BLUE BIRD

**SUBJECT: RECALL R11SU FMVSS 221 JOINT STRENGTH NONCOMPLIANCE-
ADHESIVE OMITTED AT 20 GAUGE OUTSIDE SIDE
PANEL JOINTS**

FMVSS 221 Joint Strength Noncompliance Adhesive Omitted on 20 Gauge Outside Side Panels

**Models Affected: 2010 Model Year All American (D3) Model School Buses
with Optional 20 Gauge Outside Side Panels**

Photo 1
Spacing from bottom edge of window line rub rail to floor line.

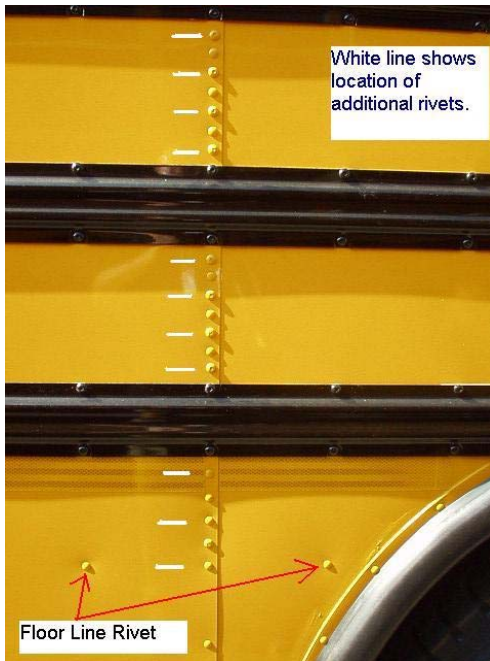
Adhesive required to meet FMVSS 221 Joint Strength requirements may have been omitted at 20 gauge outside side panel joints.

- Using a 17/64" drill bit, drill additional rivet holes at each outside side panel joint as indicated by white dash line in Photo #1 below. A drill stop set at 1/2" (0.50) must be used to prevent possible damage to wires in bow cavities. Be sure holes are evenly spaced between existing rivets and that holes stay in line with existing rivets.

Install additional rivets as required to comply with FMVSS 221 Joint Strength requirements.

- Install part number #01854397 Rivet, Blind, .25 Dia, .38 grip, in each hole drilled using a rivet gun/tool.
- On the street side of the bus, remove the stop arm to allow installation of the additional rivets in beltline area, then reinstall stop arm.
